BOROUGH OF CONSHOHOCKEN

DECEMBER 12, 2024 PLANNING COMMISSION MEETING PACKET

101 Washington St SEPTA Surface Lot Project Waiver of LD Application

2 PIPE PROFILE: INL-302 TO MH-301
SCALE: 1" = 1' HORIZONTAL
1" = 5' VERTICAL

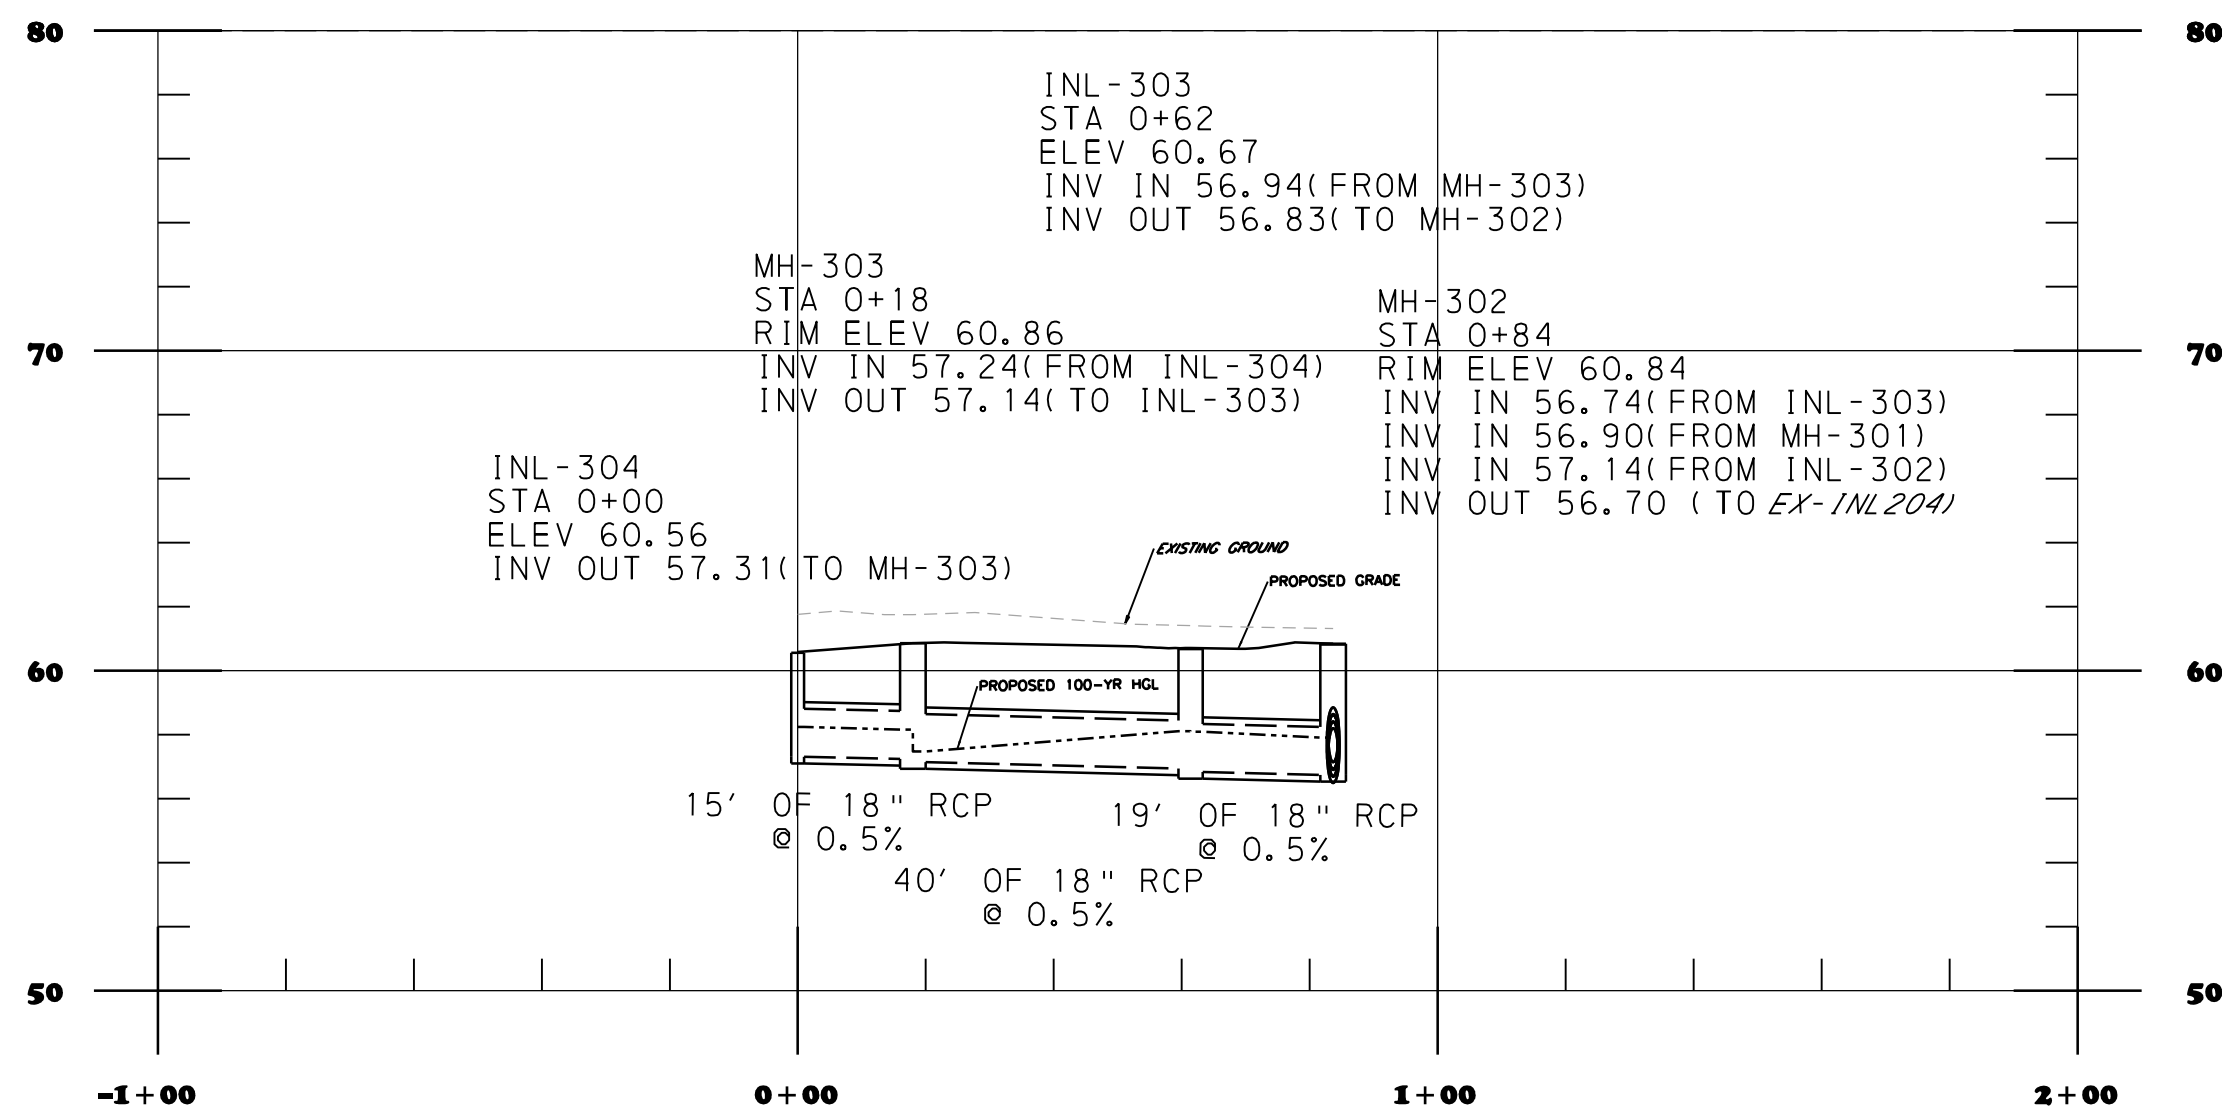
21. On Plan Sheet 55 (Erosion and Sediment Control Plan) – show the location for the concrete washout.
22. On Plan Sheet 74 (Drainage Profiles) – show the proposed water main utility crossings on the profile and dimension the separation between the storm and water utilities.
